APPLICATION FOR SUBMITTAL OF POST-APPROVAL DOCUMENT

2. PROJECT INFORMATION:			
School District/Owner: Lodi Unified School District		DSA File Number: 39 H4	
Project Name/School: Lodi High School Breezeway Repair		DSA Application Number 02 121377

CCD NO. 01 NARRATIVE

School District/Owner: **Lodi Unified School District**
Project Name/School: **Lodi High School**
DSA File/Appl No.: **39-H4 /02-121377**
CCD Number: **#01**

METAL STUD SOFFIT AT(E) WINDOW W/ METAL STUD CEILING ATTACHMENT

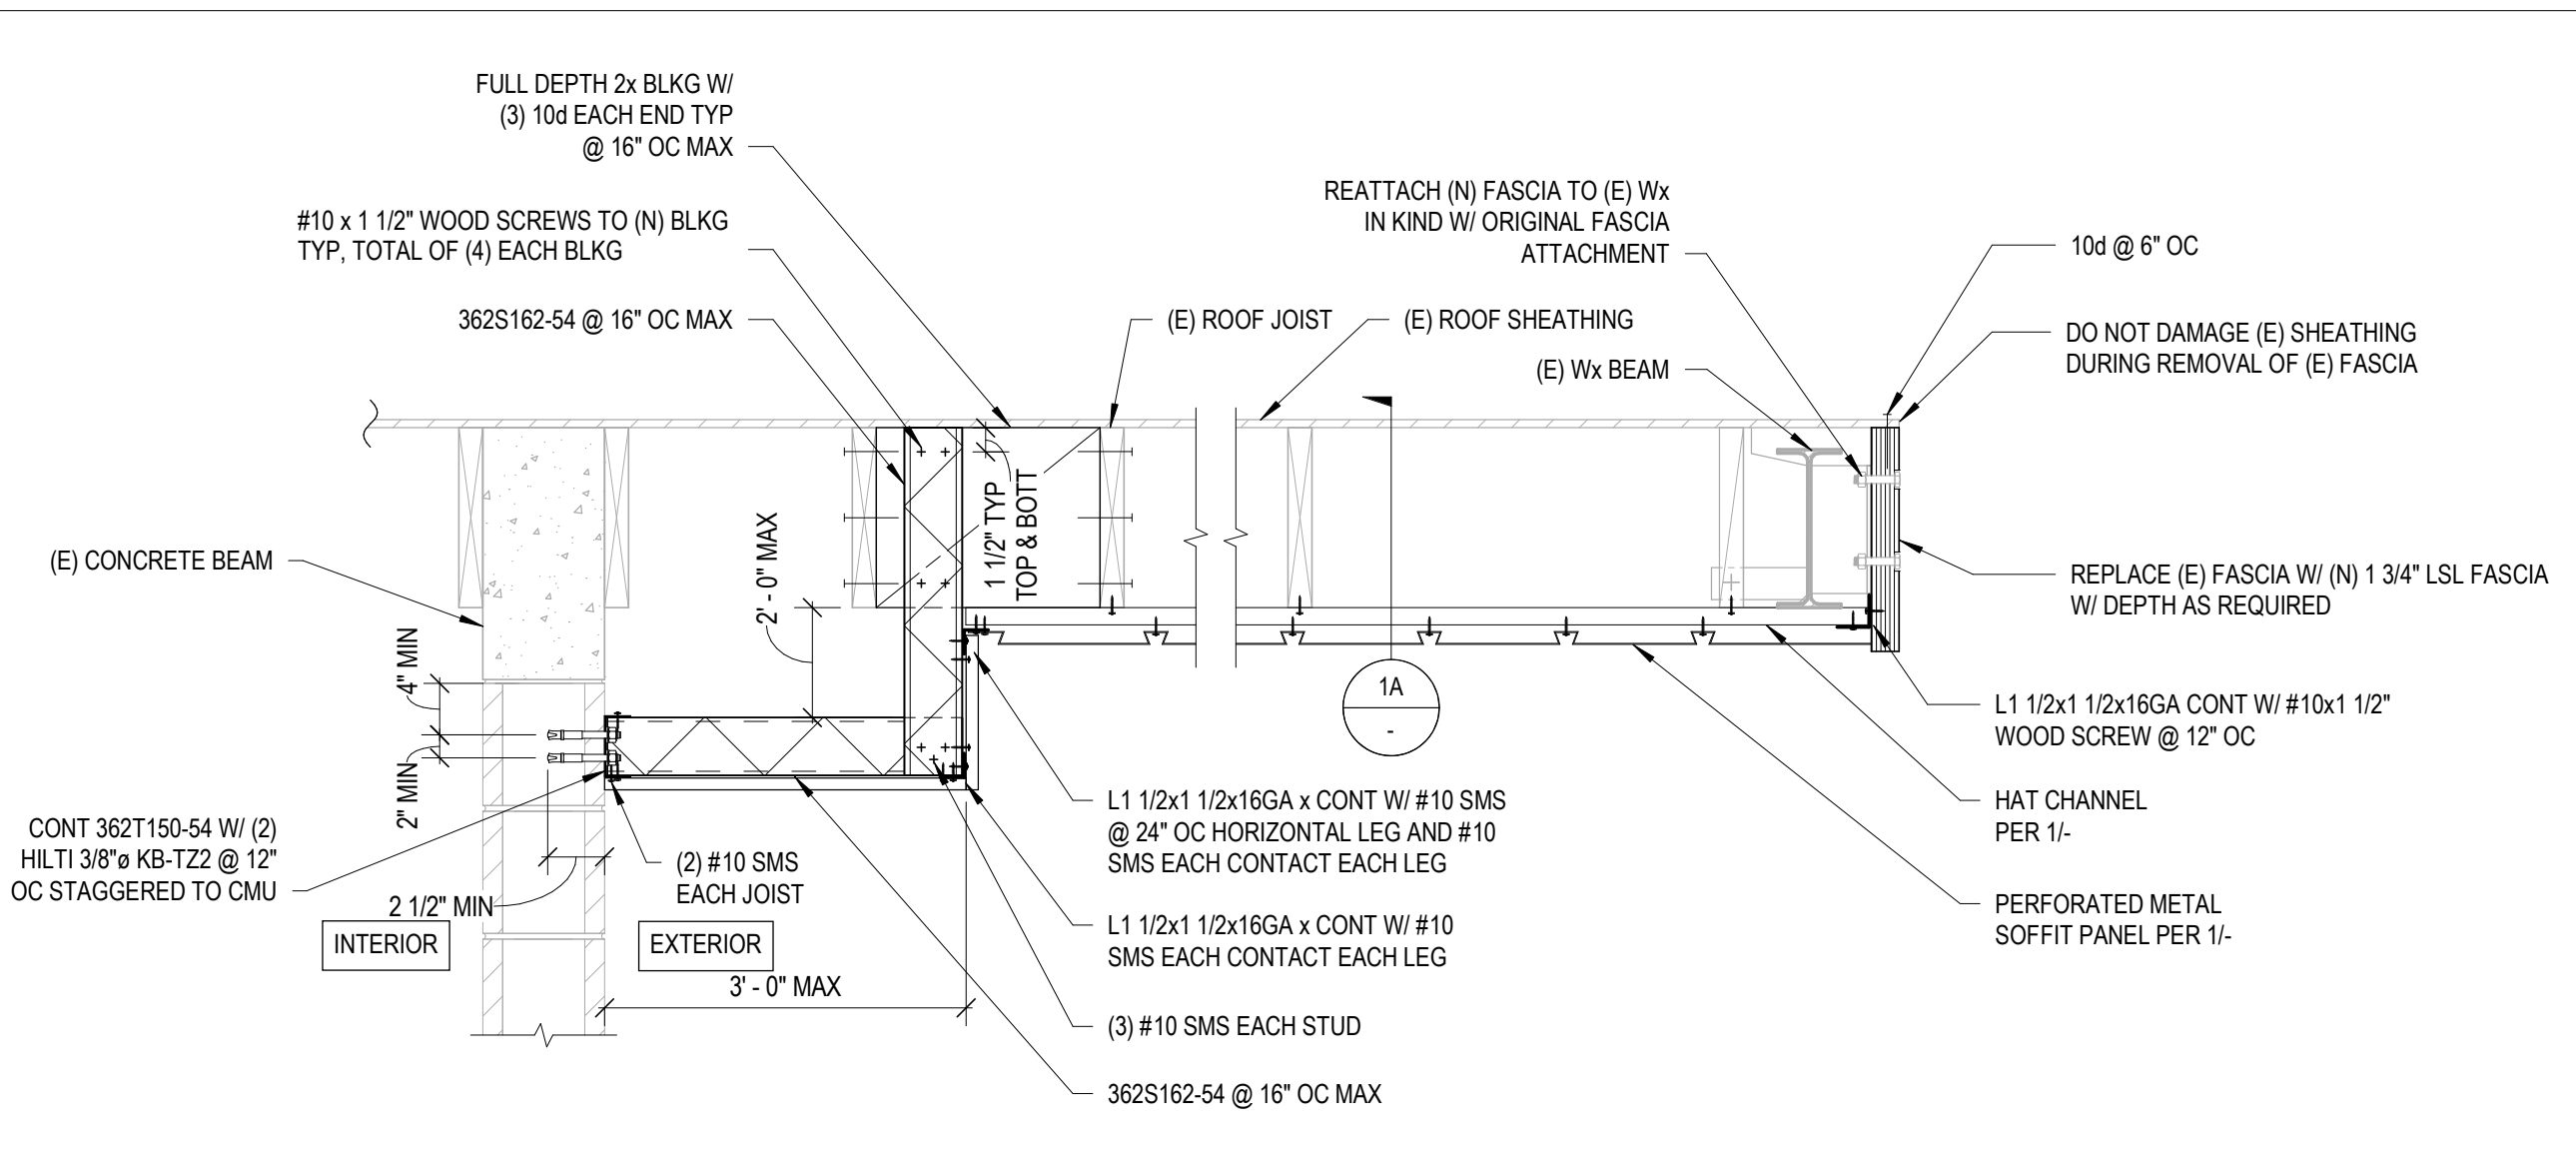
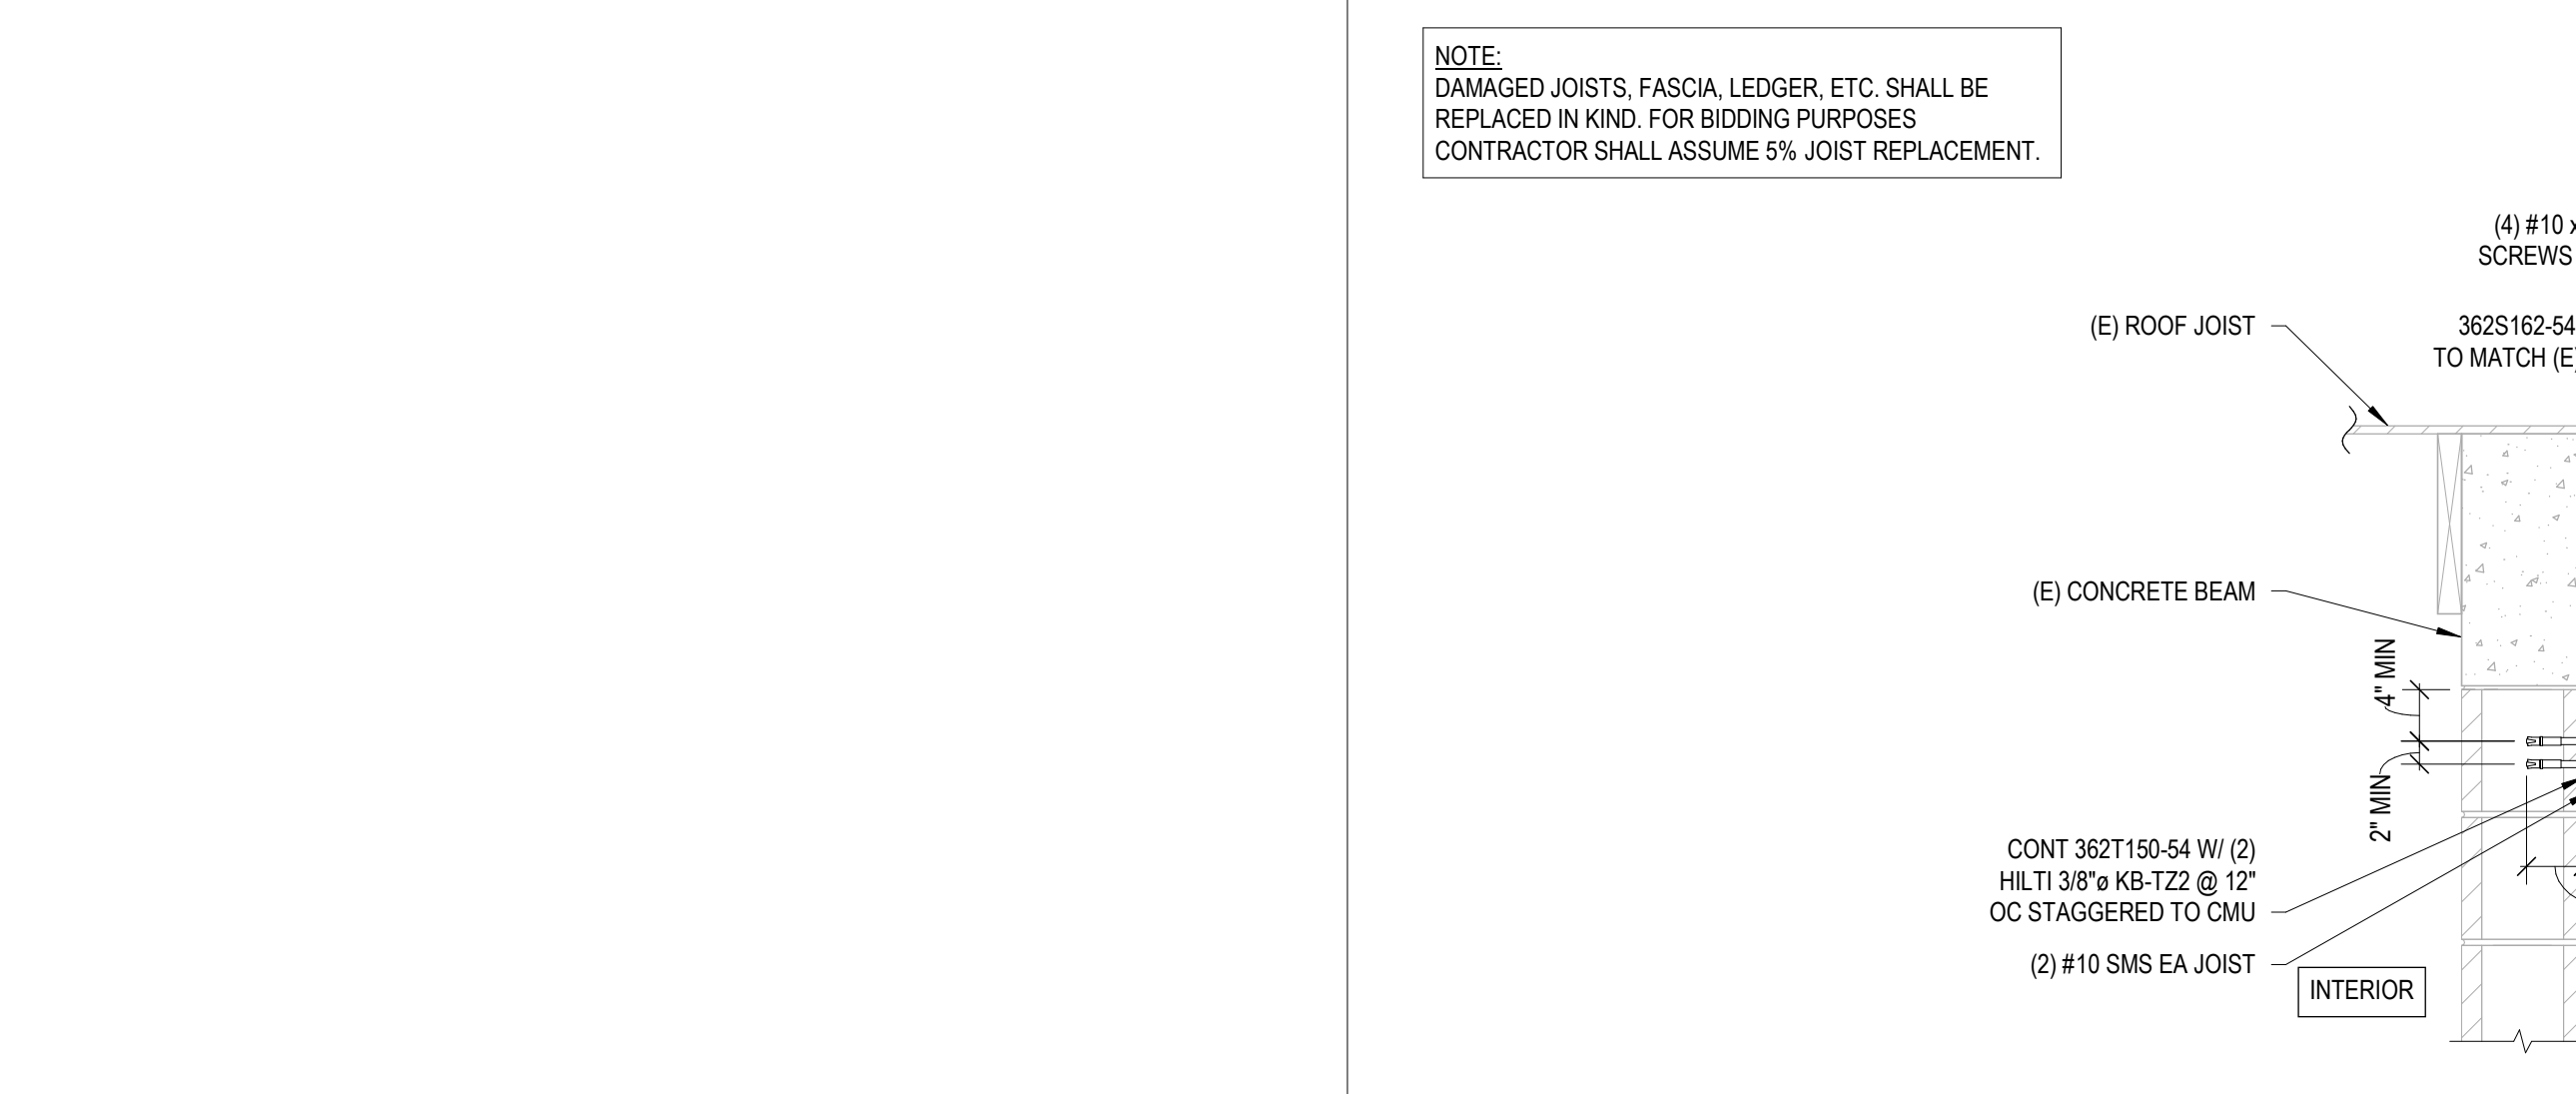
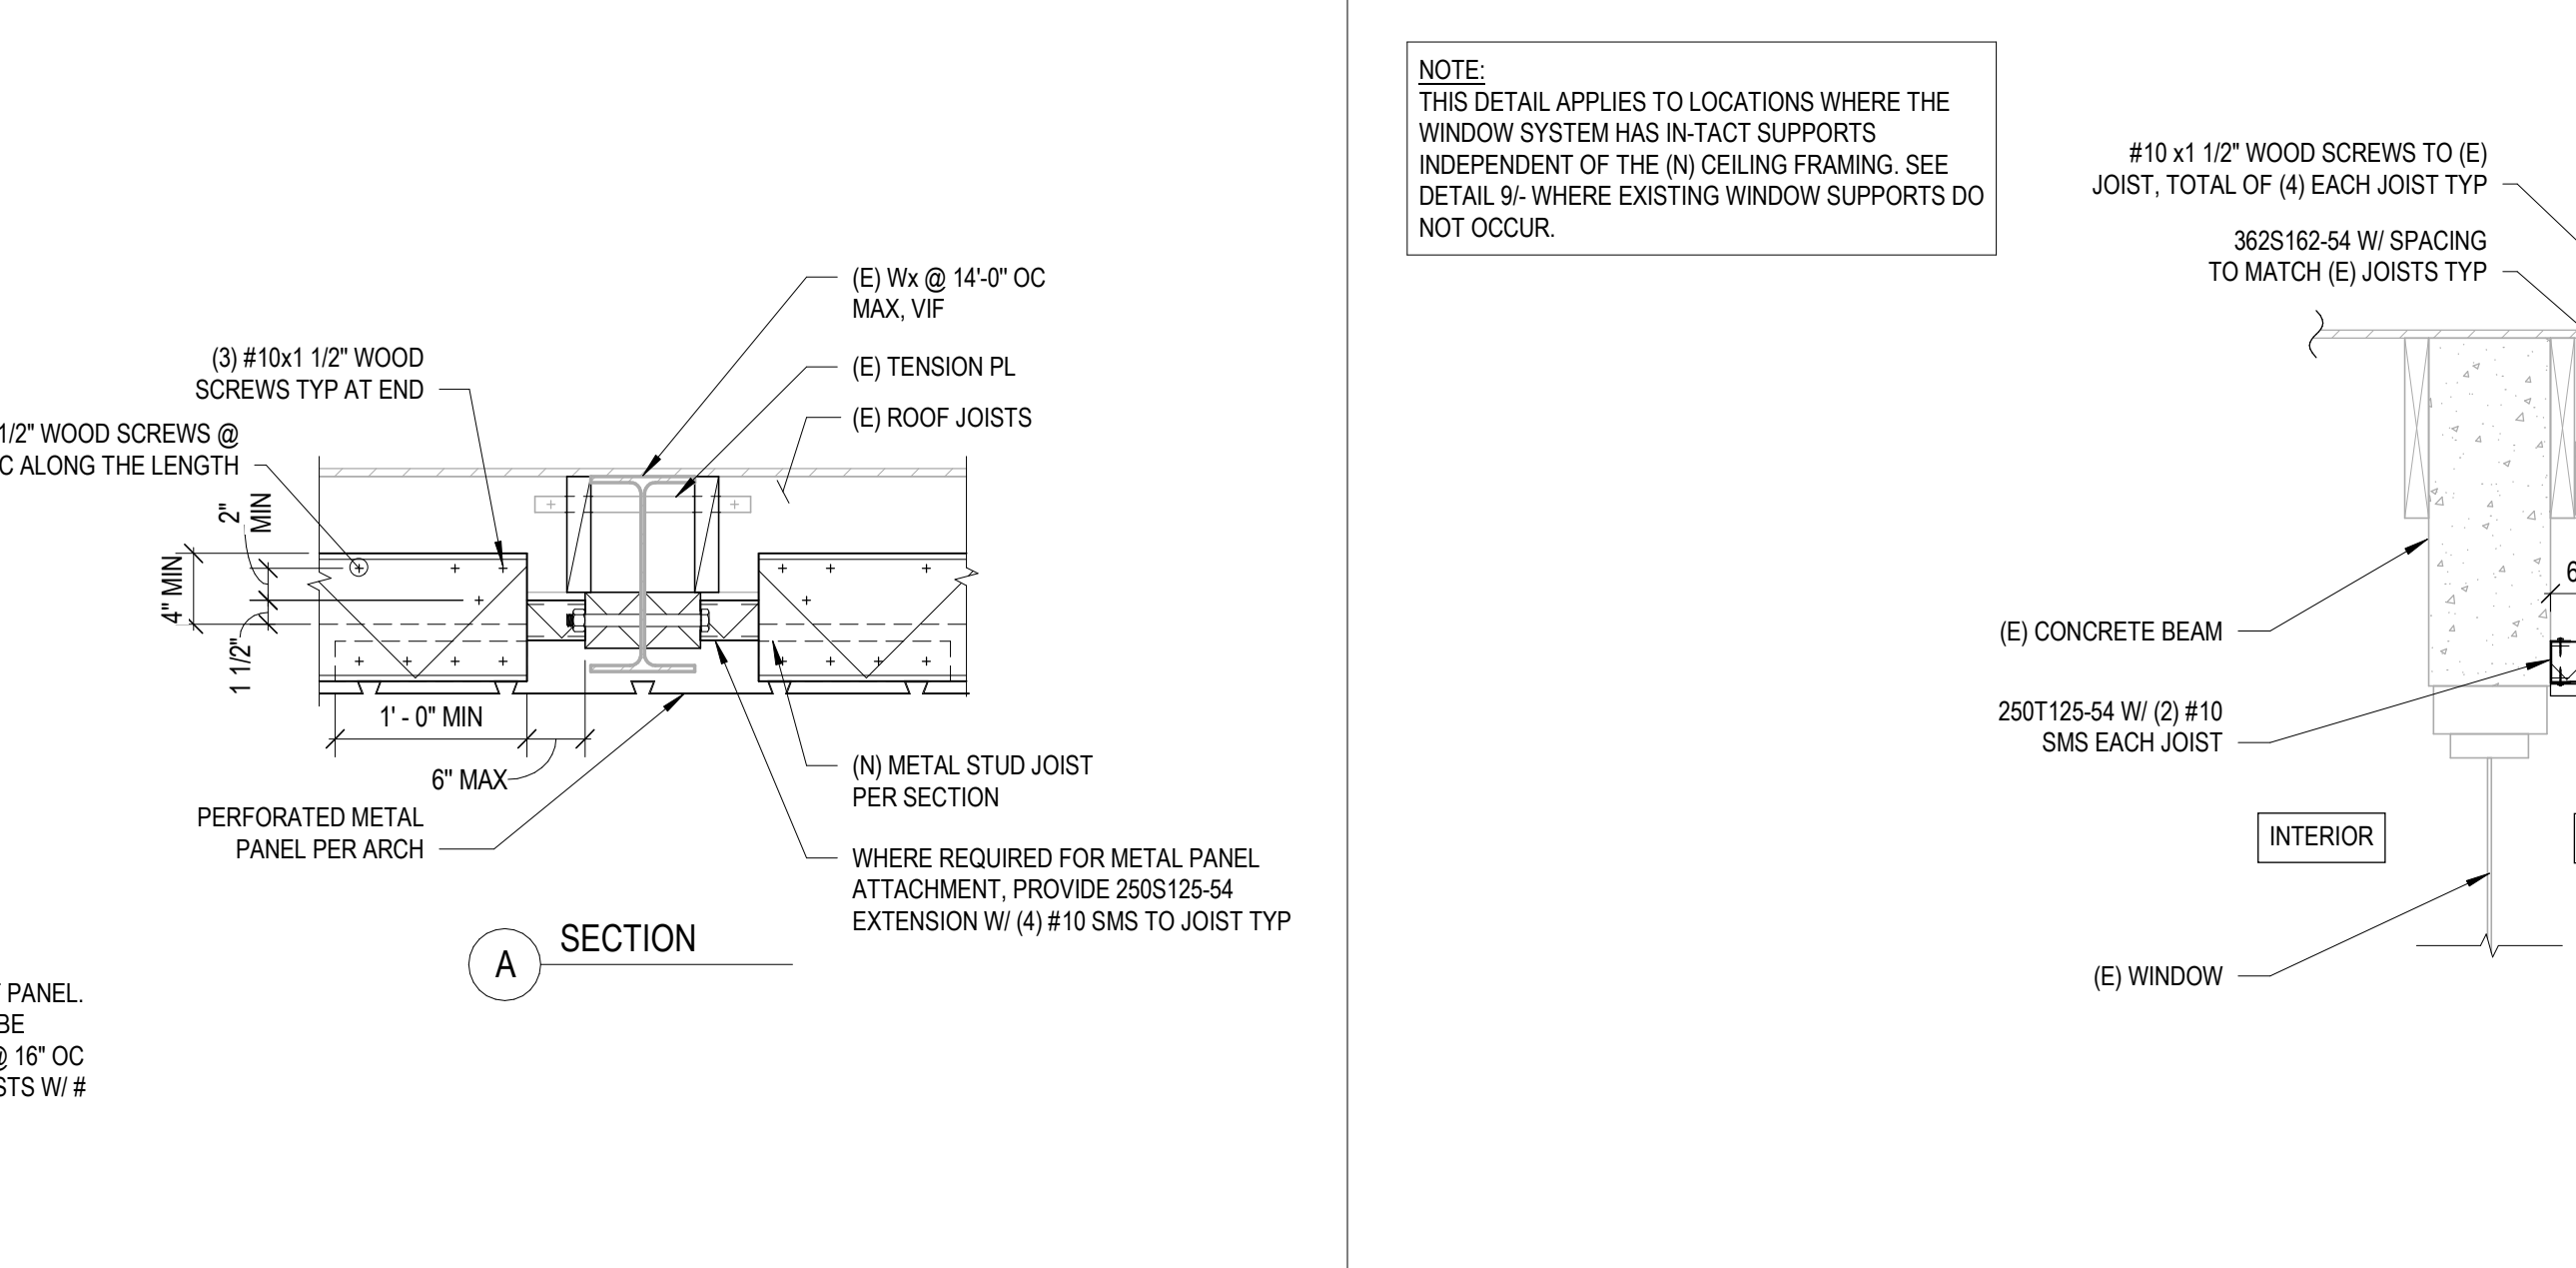
Details on sheet S2.1 have been revised to reflect new non-structural framing required to support an air barrier above windows. Additionally, sketches SK-01 – SK-06 have been included to show new support framing required for the currently unsupported section of plaster at the interior edge of the existing window systems.
